**COMMONWEALTH OF KENTUCKY
TRANSPORTATION CABINET**
Frankfort, Kentucky 40622
www.transportation.ky.gov/

CALL NO. 301
CONTRACT ID NO. 171239
ADDENDUM # 1

Subject: Menifee County, FD04 SPP 083 0036 002-005
Letting September 29, 2017

- (1) Revised - Plans - R2D, R5, R9, R23, R44, & R45
- (2) Revised - Bid Items - Pages 74-75 of 75

CULVERT AT STA. 51+78.11
SITUATION SURVEY SHEET

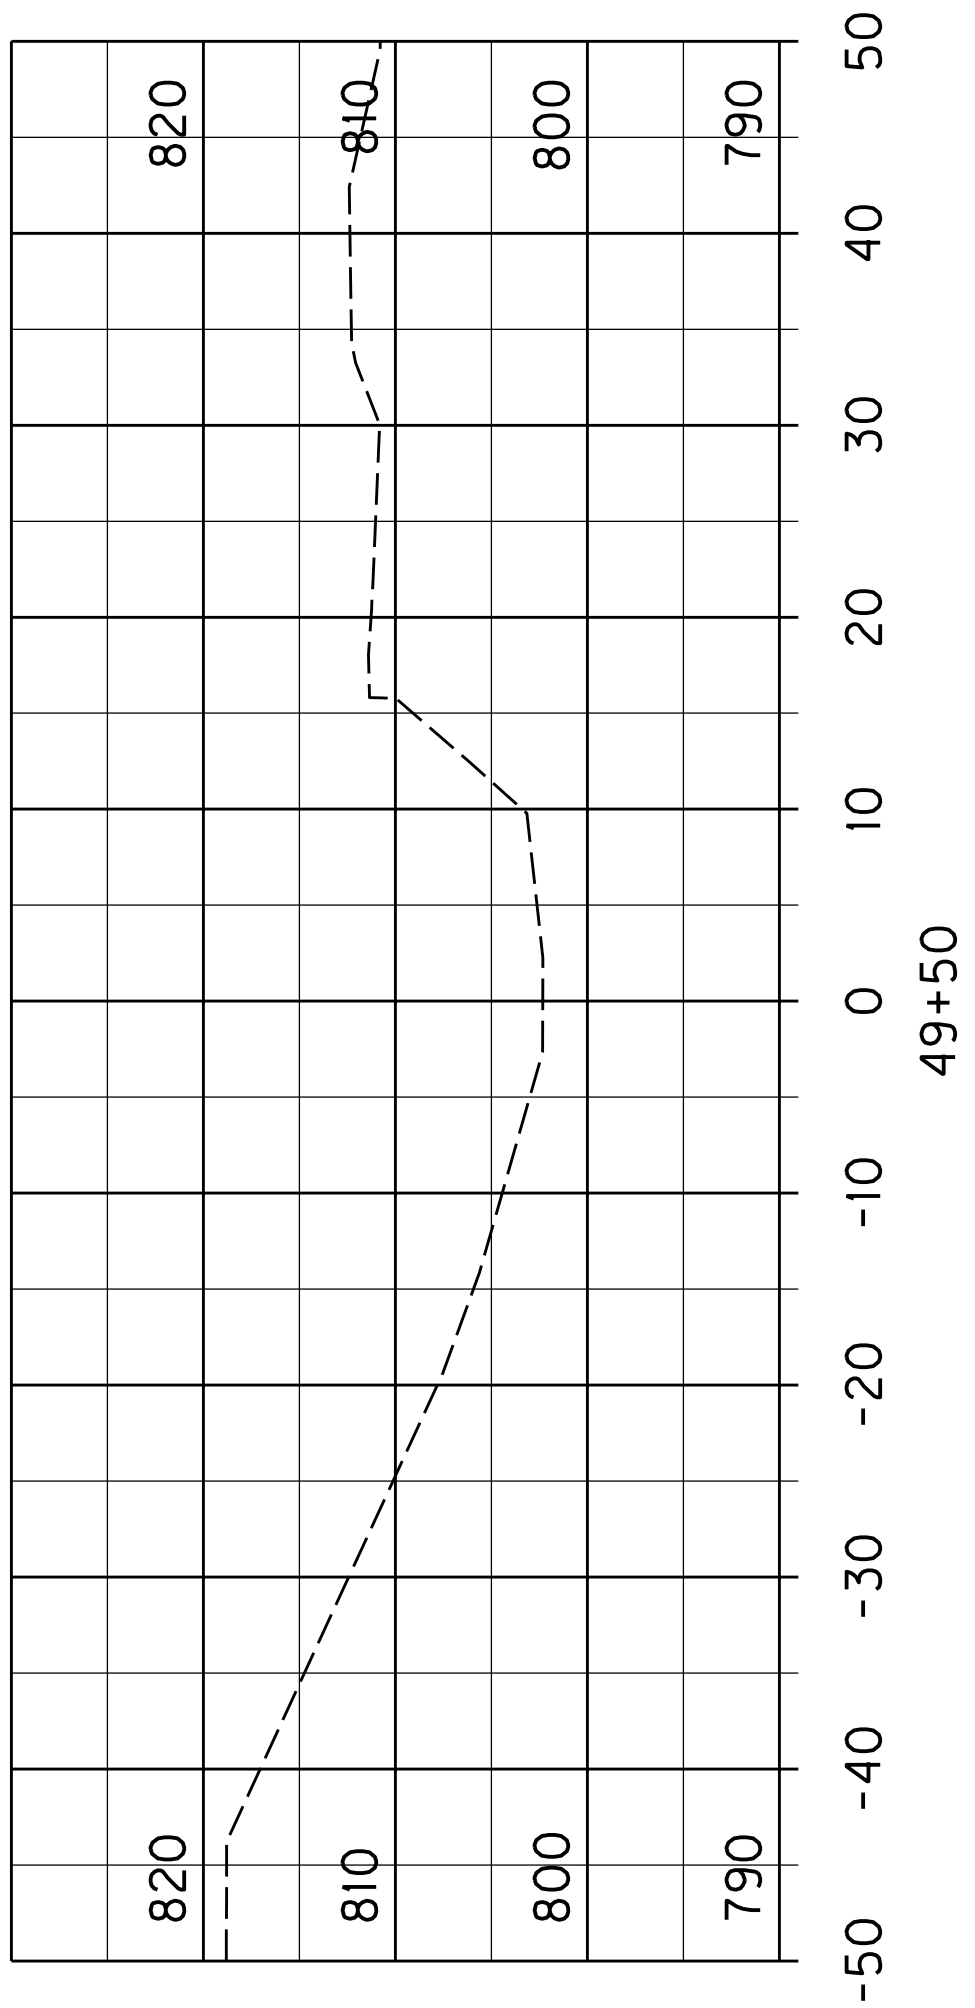
REVISED 09/18/2017
